UNITED STATES PATENT AND TRADEMARK OFFICE

APPLICATION NO.	FILING DATE	FIRST NAMED INVENTOR	ATTORNEY DOCKET NO.	CONFIRMATION NO.
10/821,617	04/09/2004	Eric L. Gray	75028-307898	8940
43541	7590	10/10/2006	EXAMINER	
WOOD, HERRON & EVANS (ZIMMER SPINE) 2700 CAREW TOWER 441 VINE STREET CINCINNATI, OH 45202			SAN MIGUEL, ANITZA M	
			ART UNIT	PAPER NUMBER
			3733

Office Action Summary	Application No. 10/821,617	Applicant(s) GRAY ET AL.	
	Examiner Anitza M. San Miguel	Art Unit 3733

DETAILED ACTION

Figure 1

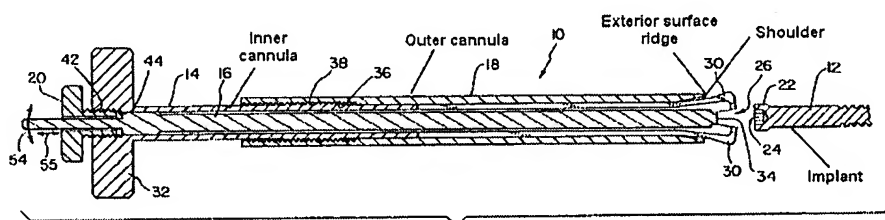
Bryant et al. discloses a spinal surgical instrument comprising: an outer cannula having a proximal end, distal end and an outer lumen passing therebetween, the distal end of the outer lumen configured to releasably mount to a securing arrangement for a spinal implant; an inner cannula having a proximal end, a distal end and an inner lumen passing therebetween, the inner cannula being axially moveable within the outer lumen of the outer cannula; a fixing member having a proximal end and a distal end, the fixing

member positioned within the inner lumen and including an arrangement for advancing and retracting the fixing member within the inner lumen of the inner cannula (see Figure 1 and 2).

The inner cannula is axially moveable within the outer lumen of the outer cannula for a predetermined distance between a first position and a second position. The distal end of the outer lumen is configured to releasably engage a locking nut. The outer cannula includes an exterior surface contour to facilitate gripping of the outer cannula. The distal end of the inner lumen includes an axially directed shoulder that can abut against a proximal end of the spinal implant (see Figure 1 and 2).
